MOORPARK CITY COUNCIL AGENDA REPORT

SUBJECT: Consider Draft Environmental Impact Report (EIR) for the Proposed Southern California Edison Presidential Substation Project and Utilities, Located within Various Rights of Ways in the County of Ventura, and the Cities of Simi Valley and Thousand Oaks

Re: Supplemental Public Scoping for Presidential Substation EIR

Presidential Substation Project . 207584.02
Figure ES-2
 Alternative Subtransmission Alignments

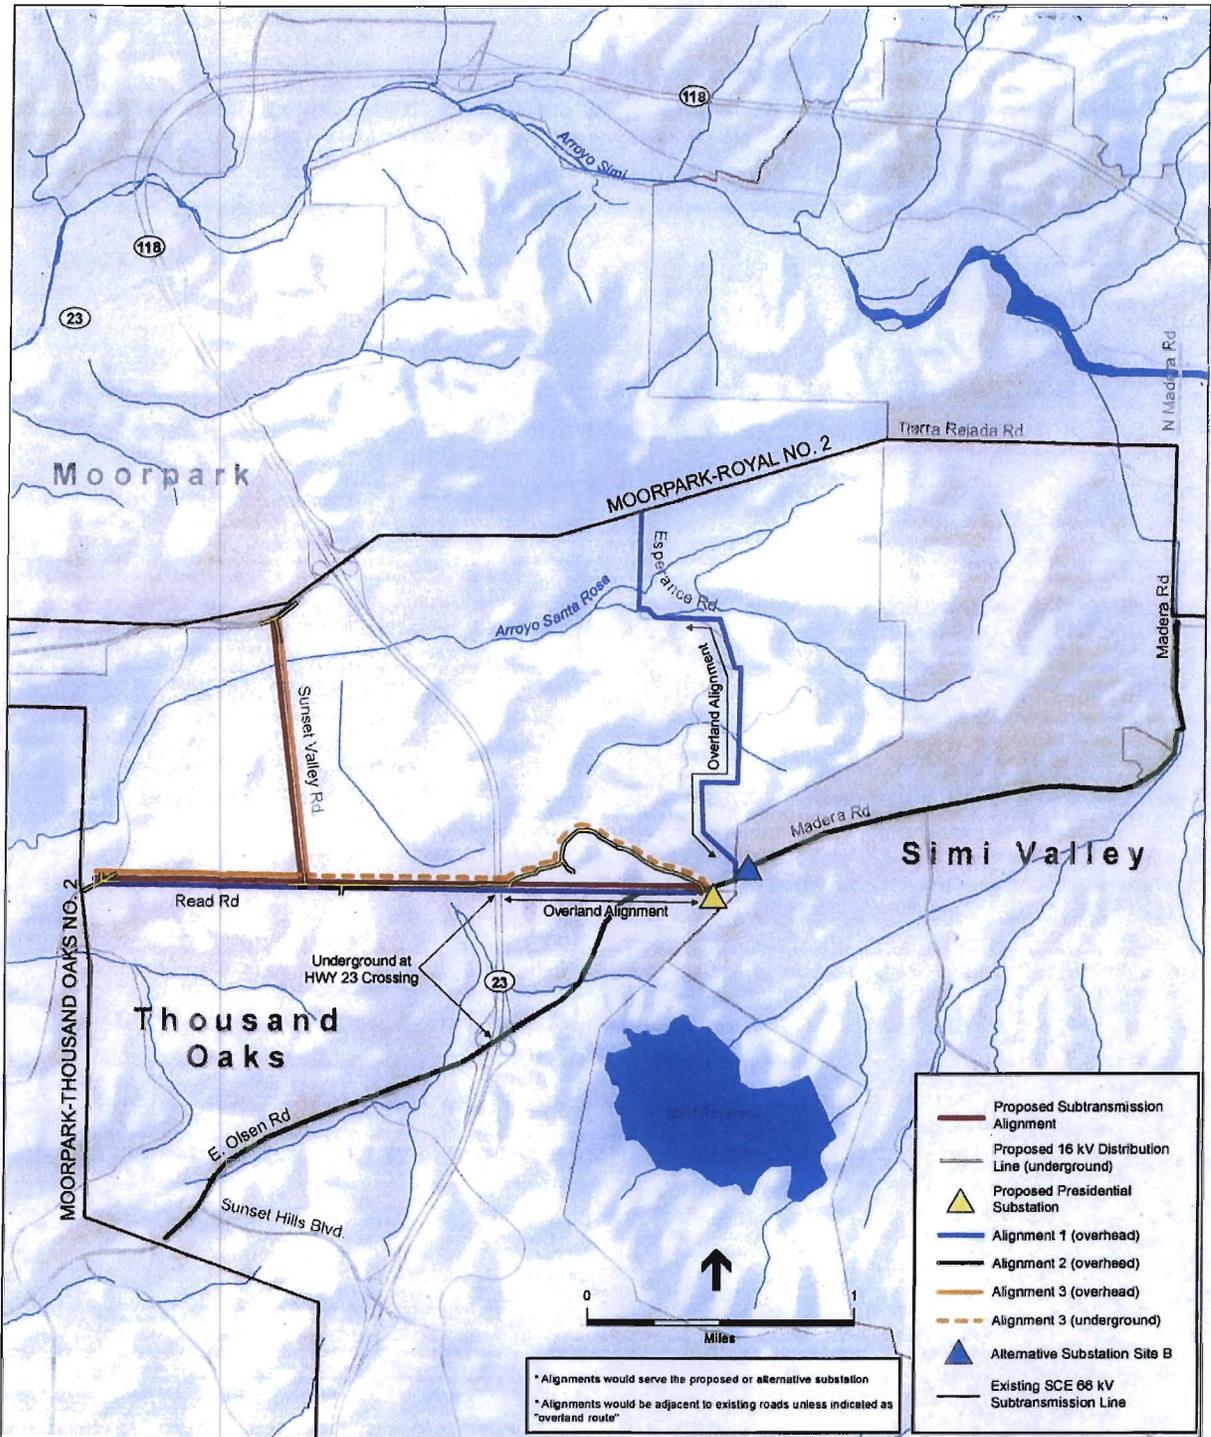
In reviewing the Draft EIR, staff believes the draft has not adequately addressed the City's comments raised during scoping. Staff recommended analyzing a project alternative which includes full undergrounding of the 66kV transmission lines through

the Tierra Rejada Valley. This alternative was described on pages 3-26 and 3-27, as Alternative Subtransmission Alignment 4, which was eliminated from consideration in the Draft EIR because impacts to air quality, and noise resources would increase and an additional potentially significant cultural resources impact would occur. In addition, the Draft EIR states that the impacts on aesthetic resources would not be reduced more than under Alternative Subtransmission Alignment 3 which also reduced noise and air quality impacts and was carried forward for analysis. Staff is recommending that the EIR include Alternative Subtransmission Alignment 4 as an alternative and analyze in more detail its potential for reducing long range aesthetics impacts on the Tierra Rejada Valley. During scoping, staff also recommended a 66kV pole route location alternative, where the new lines would follow the existing north-south 66kV lines to the west of the Tierra Rejada Valley from Tierra Rejada Road to Read Road instead of creating a new path along Sunset Valley Road; from Read Road east, this alternative should have been explored as both an underground and an above-ground line. This requested alternative was not evaluated in the EIR, even though staff believes it may show a significant reduction in project impacts to the Tierra Rejada Valley, thereby improving the decision-making process on this project as a reasonable alternative.

In addition, the Draft EIR does not adequately address the City's scoping comments previously submitted because it does not provide an alternative for the full undergrounding of the new 66kV and 16kV transmission lines through the Tierra Rejada Valley. Also, the EIR alternatives do not include a 66kV pole route location alternative, where the new lines would follow the existing north-south 66kV lines to the west of the Tierra Rejada Valley from Tierra Rejada Road to Read Road instead of creating a new path along Sunset Valley Road. From Read Road east, this alternative should be explored as both an underground and an above-ground line. Staff had originally requested that these alternatives be included and evaluated in the Draft EIR. These alternatives, if considered, may significantly reduce aesthetic project impacts to the Tierra Rejada Valley.

2. The Draft EIR does not adequately address the City's scoping comments previously submitted, because it does not provide an alternative for the full undergrounding of the new 66kV and 16kV transmission lines through the Tierra Rejada Valley. Also, the EIR alternatives do not include a 66kV pole route location alternative, where the new lines would follow the existing north-south 66kV lines to the west of the Tierra Rejada Valley from Tierra Rejada Road to Read Road instead of creating a new path along Sunset Valley Road. From Read Road east, this alternative should be explored as both an underground and an above-ground line. The City had originally requested that these alternatives be included and evaluated in the Draft EIR. These alternatives, if considered, may significantly reduce aesthetic project impacts to the Tierra Rejada Valley.
